Agenda
Village of Arlington Heights
Design Commission
Buechner Room, 1st Floor

Arlington Heights Village Hall
33 S. Arlington Heights Road
Arlington Heights, IL 60005
April 26, 2016
6:30 PM

**MINUTES OF
THE VILLAGE OF ARLINGTON HEIGHTS
DESIGN COMMISSION MEETING
HELD AT THE ARLINGTON HEIGHTS MUNICIPAL BUILDING
33 S. ARLINGTON HEIGHTS RD.
APRIL 12, 2016**

SITE PLAN

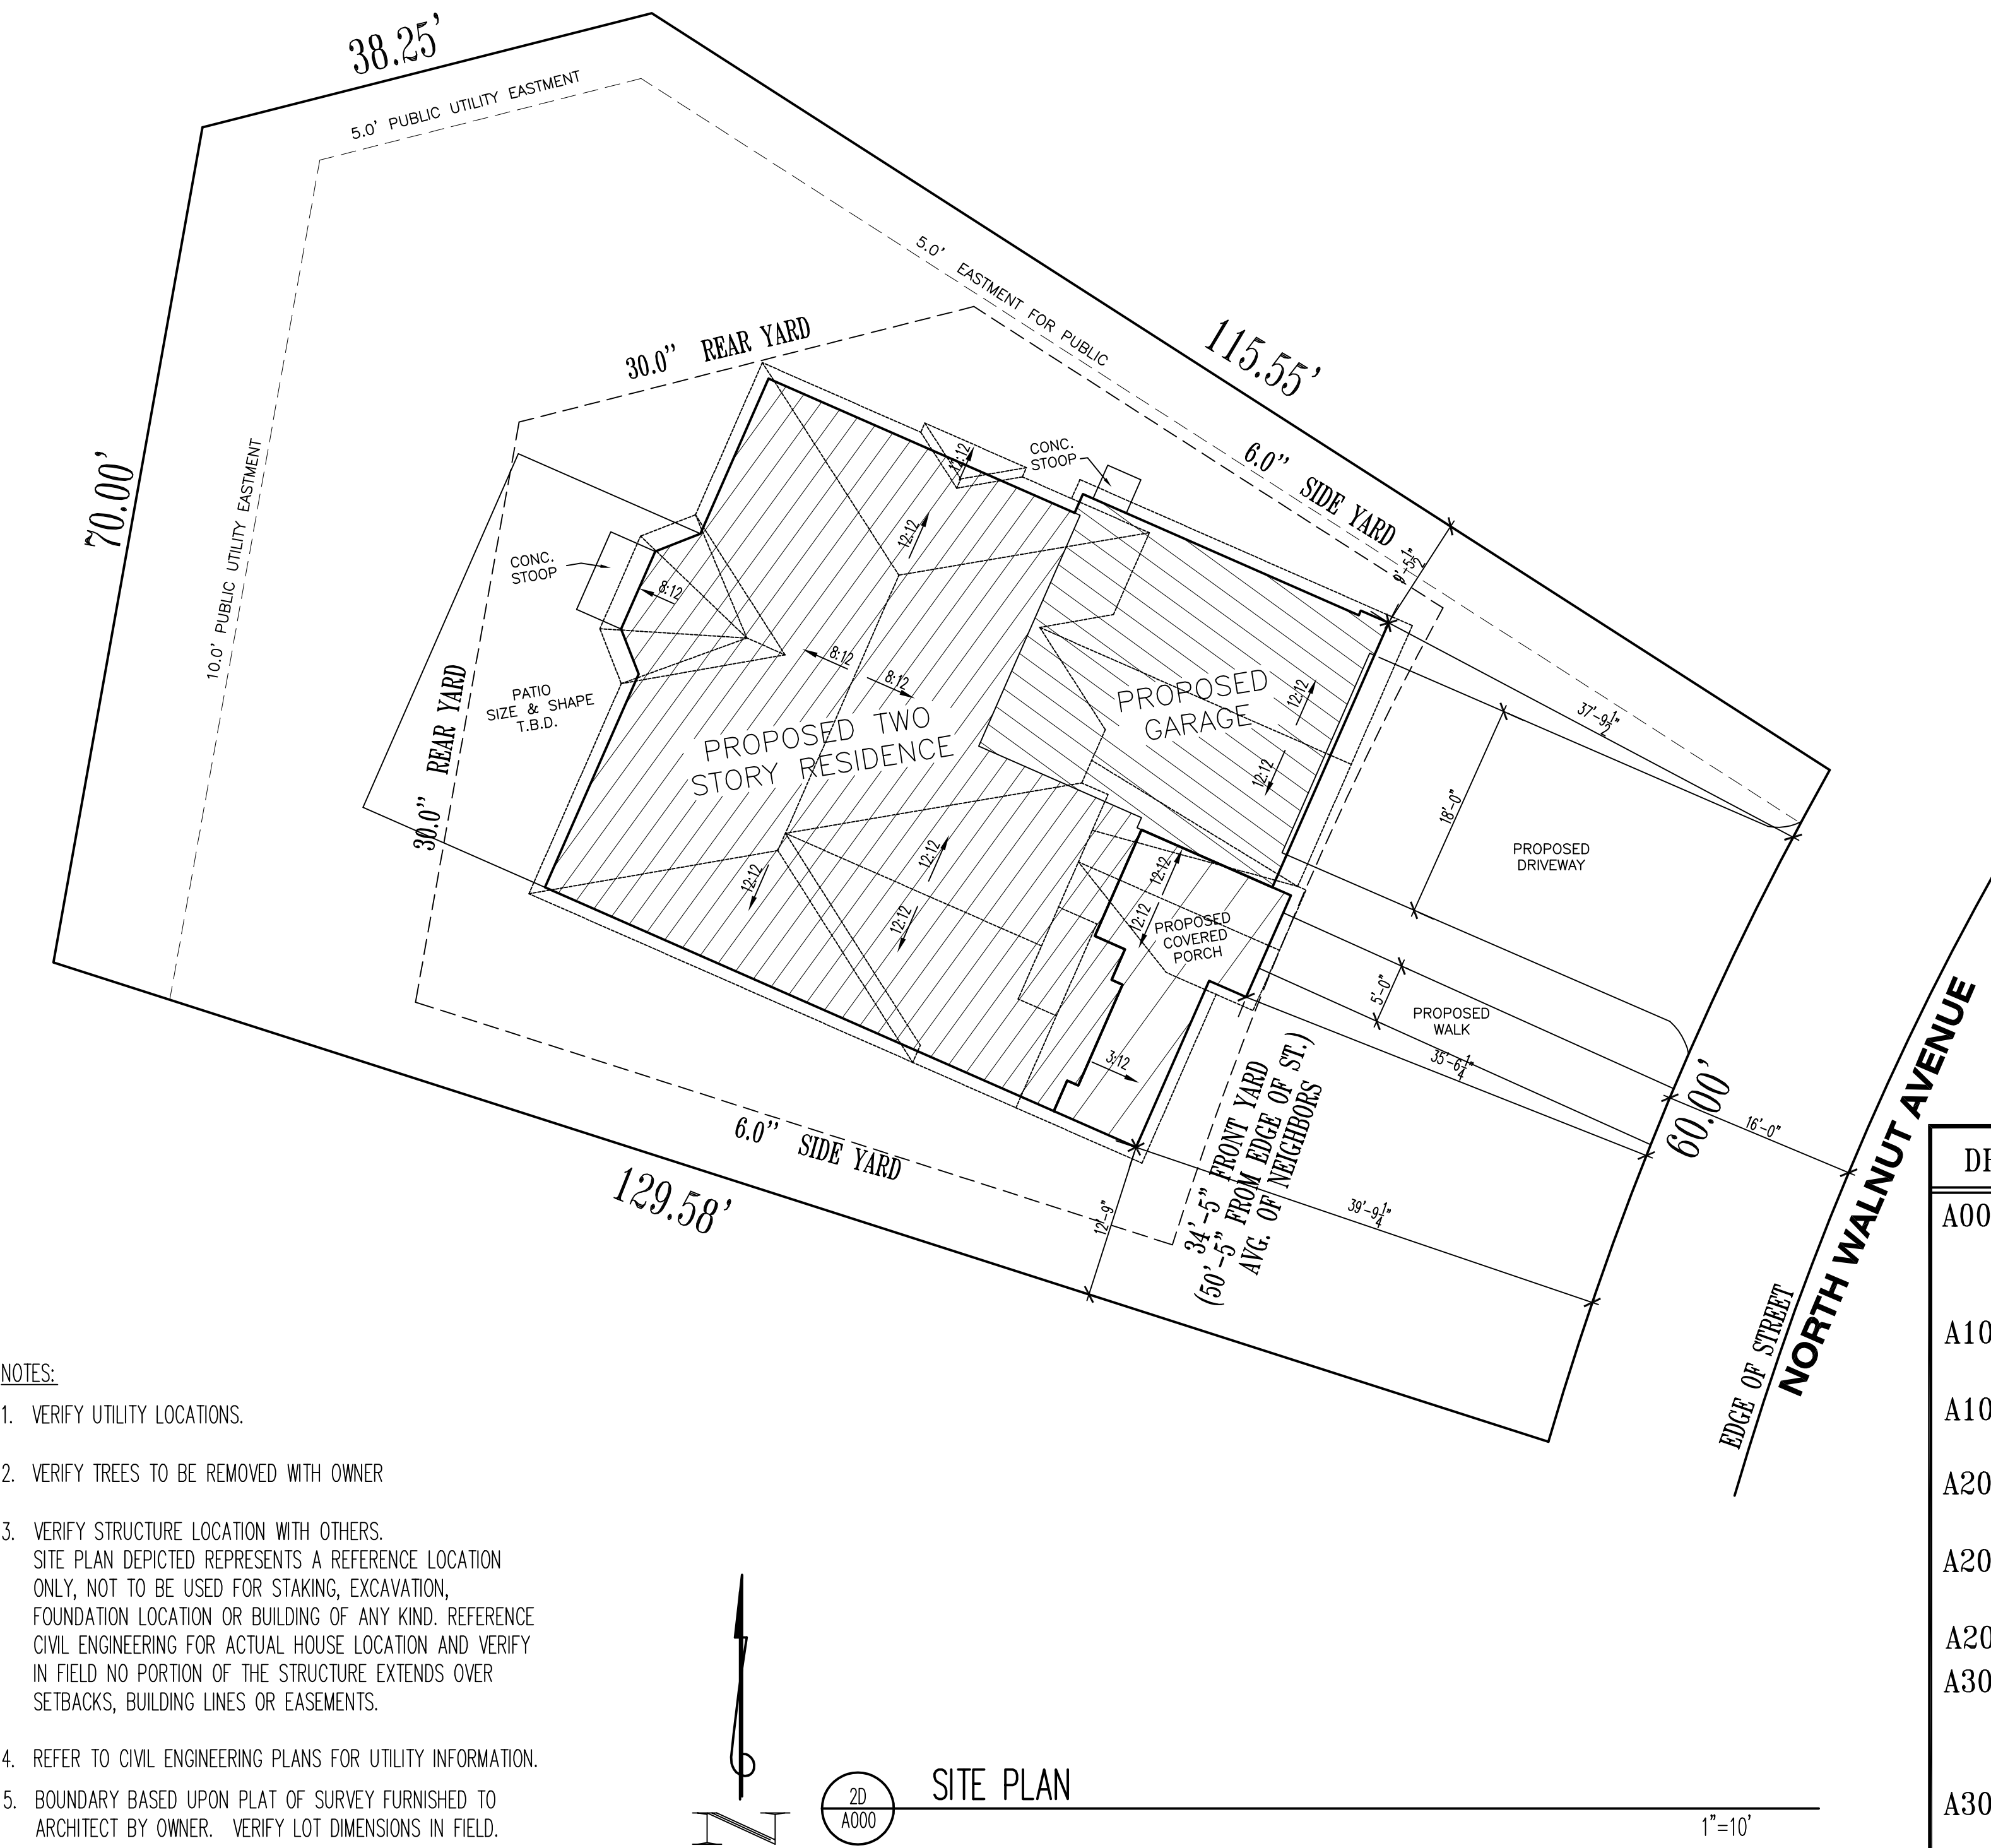
Additionally, the Site Plan is incorrectly drawn with a 60 foot wide front property line, where the actual width is 68 feet.

1. Resolve the driveway conflict with the parkway tree so that the parkway tree can remain. A minimum of ten feet clearance should be maintained.
2. Correct the Site Plan with the correct lot width.

3E
A202
PROPOSED FRONT ELEVATION
1534 N. WALNUT AVE.
SUBJECT PROPERTY
1/8"=1'-0"

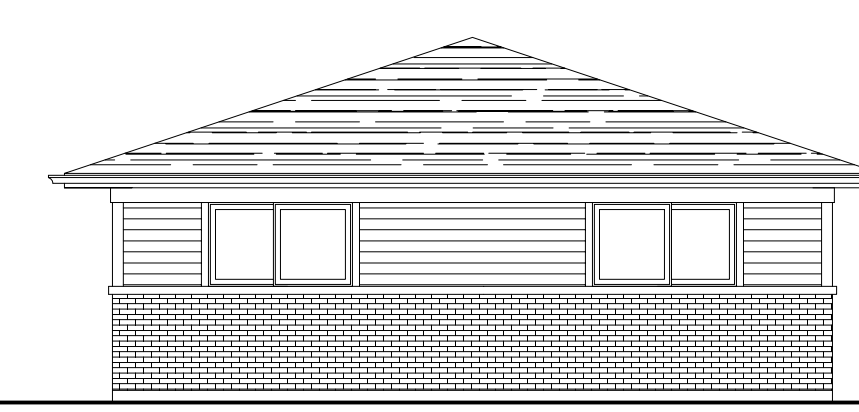
Overall, the proposed design is consistent with the other newer homes approved in this neighborhood. Features such as the single story front porch and single story garage roof help the design to fit in with the adjacent single story homes, and the hipped main roof keeps the height of the side walls from being too tall. The garage is somewhat prominent on the front of the home, but the front porch does extend out to align with the garage wall. The only suggested change to the design is to continue the stone base down the side of the garage.
